50 CONDOVER STREET, NORTH BALGOWLAH
STATEMENT OF MODIFICATION | NORTHERN BEACHES COUNCIL
FOR: SECTION 4.55 MODIFICATION OF CONSENT FOR MINOR MODIFICATIONS
20.12.2022

Consent was granted for DA 2023/0541 by the Northern Beaches Council on 8 January 2024. The approved design comprised of two dwelling houses and pools to replace the existing dwelling at 50 Condoval street, North Balgowlah (Lot 4 DP 30205). The new dwellings on the approved DA are on separate lots, described in the application as; Lot 1, Kimo St and Lot 2, Condoval St.

APPROVED: ROOF PLAN**MODIFIED: ROOF PLAN**

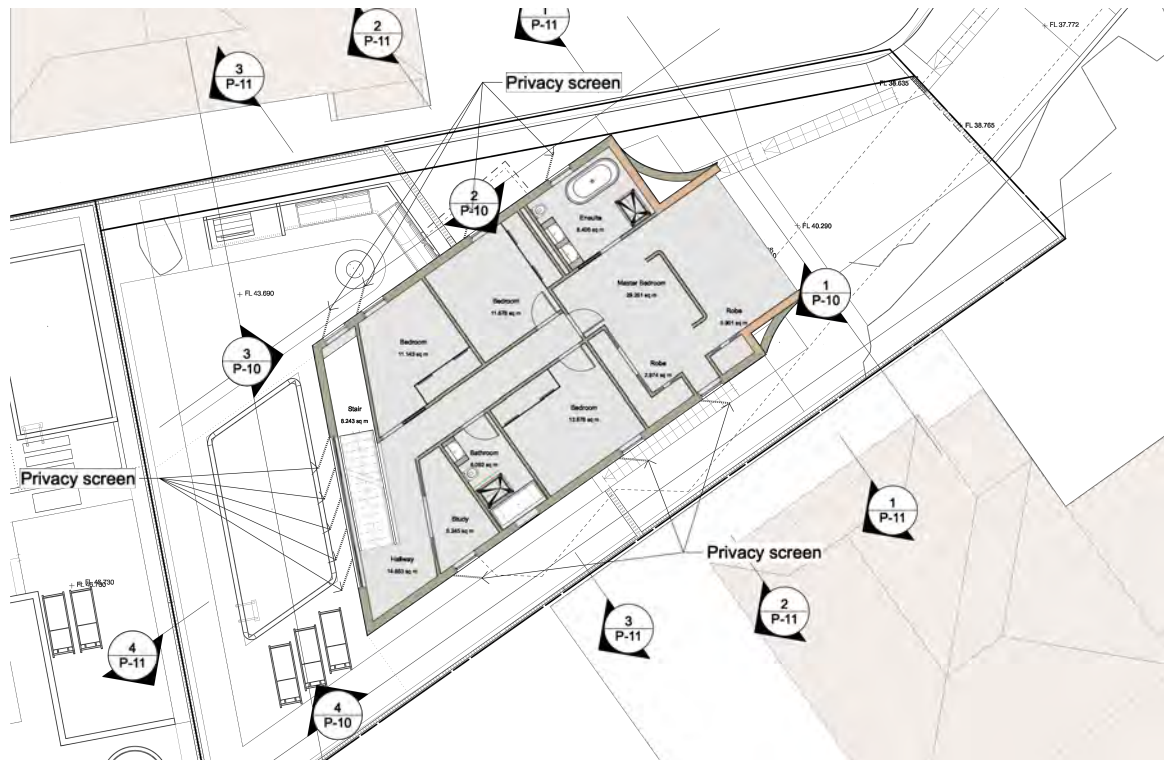
ITEM	DESCRIPTION OF PROPOSED MODIFICATIONS
Skylights Reduced	The approved 6.8m ² skylight is proposed to be changed to two smaller skylights. The total area of the skylights is reduced.
Ridge Line shifted (RL unchanged)	The approved ridge line of the roof is proposed to be shifted from off centre to the centre of the building. The approved ridge line RL is unchanged.
Metal Trim Eave	For the purpose of weatherproofing and durability of the cladding / gutter junction, a metal trim eave with a 300mm projection is proposed to the roof perimeter.
Timber Awning (North)	Replace approved cantilevered metal awning with timber awning. The timber awning is made in the same material as the wall cladding and is structurally simpler to construct than the metal awning.
Timber Awning (South)	A new timber awning is proposed on the south facade to provide shelter over the entry door and entry stairs. The awning is made in the same material as the wall cladding.

Timber Awning (West)	Replace approved cantilevered metal awning with timber awning. The timber awning is made in the same material as the wall cladding and is structurally simpler to construct than the metal awning.
Roof Shape (simplification of step in roof)	The approved roof had a 'step' in a small area over the master bedroom (eastern end). The step was problematic for weatherproofing, structural engineering and for achieving compliant room heights. To solve these problems, it is proposed to remove the 'step' in roof by 'Joining-the-dots' from the approved ridge height and approved gutter heights.
NE Curved Wall Straightened	Level 2 & 3 curved balcony wall edges are made straight and extended to ground level for a simpler / safer structural design than the approved cantilever.
SE Curved Wall Straightened	Level 2 & 3 curved balcony wall edges are made straight and extended to ground level for a simpler / safer structural design than the approved cantilever.

APPROVED: LEVEL THREE PLAN

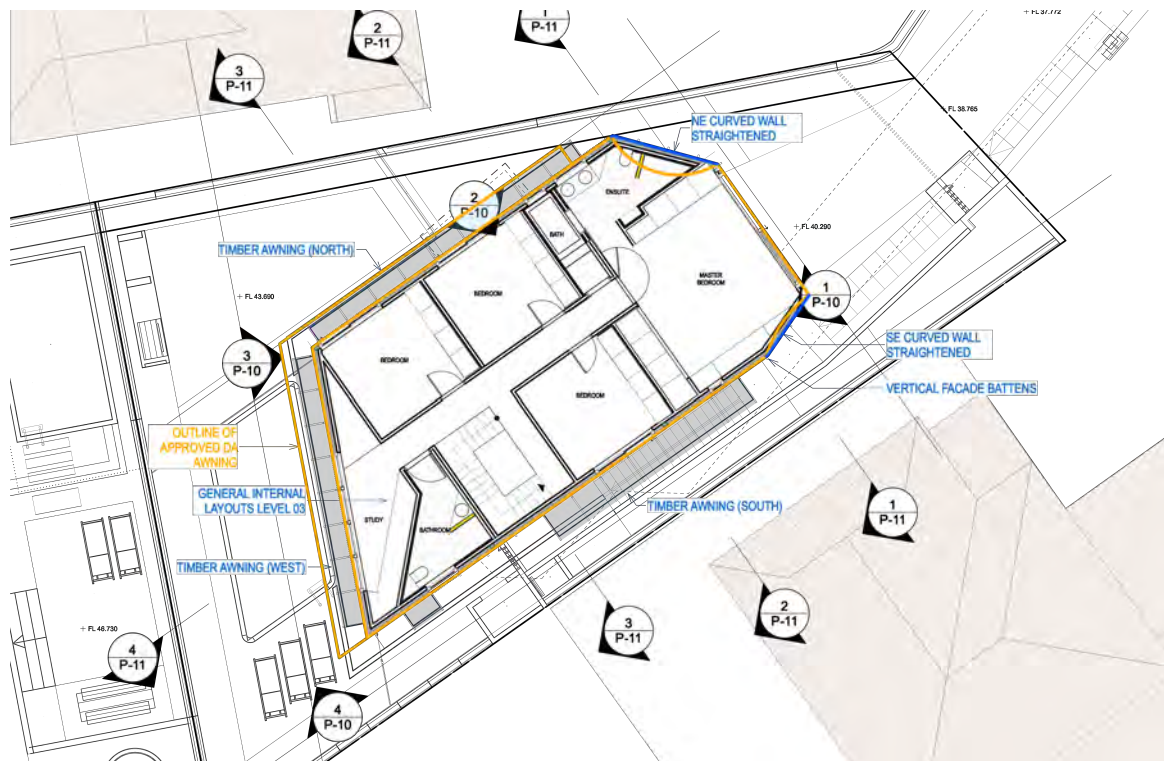
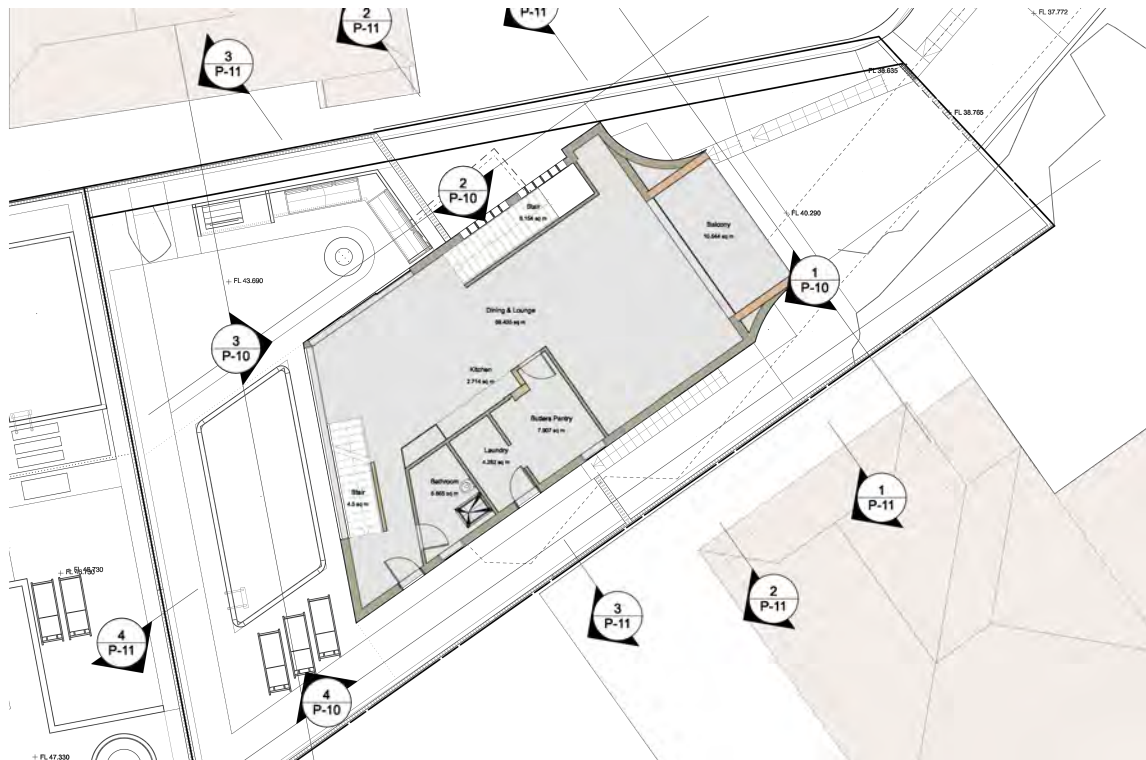
Northern Wall Alignment	300mm misalignment in level 1 & 2 north facade adjusted to vertically align with approved level 3 north facade.
Vertical Facade Battens	Grey vertical battens are added to the facade to enhance the buildings expression and rhythm.
Door Location 01	The location of the approved door is proposed to be moved in a minor way.
Window Removed	Window removed from level three
Door & Window Adjustment	A sidelight window has been proposed to the approved door
General Internal Layout Level 01	Internal layouts on level one are proposed to be re-arranged, with staircase / entry reconfigured, and areas assigned to laundry, workshop and storage.
General Internal Layout Level 02	Internal layouts on level two are proposed to be re-arranged with no change to functionality (kitchen, living, dining) other than laundry moved to level 1.
General Internal Layout Level 03	Internal layouts on level three are proposed to be re-arranged with no change to functionality (i.e 3 bedrooms, 2 bathrooms, study, staircase are consistent)

Window Adjustment 01	Window extended slightly further along the facade for improved composition of windows and visibility.
Window Adjustment 02	Slight adjustment to position of approved window at level two, for improved composition of windows and downpipes.
Window Adjustment 03	Slight adjustment to position of approved window at level three, for improved composition of windows and downpipes.

ITEM	DESCRIPTION OF PROPOSED MODIFICATIONS
Window Adjustment 04	Slight adjustment to position of approved window at level three, for improved composition of windows and downpipes, as well as better ventilation to bed rooms.
Window Adjustment 05	Slight adjustment to position of approved window at level three, for improved composition of windows and downpipes, as well as better ventilation to bed rooms.
Window Adjustment 06	Slight adjustment to position of approved window at level three, for improved composition of windows and downpipes.
Window Adjustment 07	Slight adjustment to position of approved window at level three, for improved composition of windows and downpipes.
Window Adjustment 08	Small new window proposed at level three, for improved composition of windows and downpipes. As well as allowing proper daylight to internal spaces.
Window Adjustment 09	Slight adjustment to position of approved window at level three, for improved composition of windows and downpipes, as well as better ventilation to bed rooms.

APPROVED: LEVEL TWO PLAN

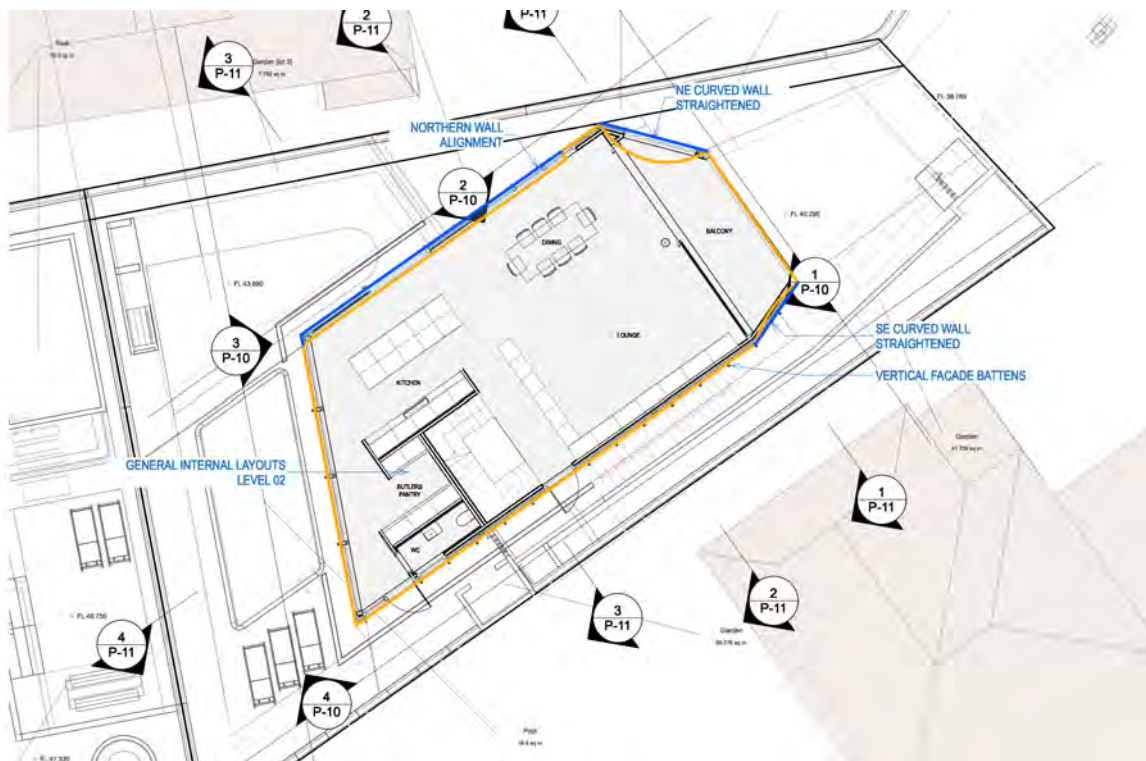
Window Adjustment 10	Slight reduction in size of approved window at level two, for improved composition of windows and downpipes.
Window Adjustment 11	Slight reduction in size of approved window at level two, for improved composition of windows and downpipes.
Window Adjustment 12	Slight increase in size of approved sliding door / window at level two, for improved composition of windows and access.
Window Adjustment 13	Slight adjustment to position of approved window at level three, for improved composition of windows and downpipes.
FFL height changed to 46.790	FFL level changed to 46.790 from 46.590 for better balance of ceiling heights between living and bedroom levels.
Landscape Adjustment 01 (Stairs to Drive)	Stair relocated to eastern side of driveway to suit new house entrance - Anti-slip stone driveway surface. A proposed mailbox location has also been added.
Landscape Adjustment 02 (Stairs to House)	Access stair location amended to suit new house entrance location and entry structure added with security gate.
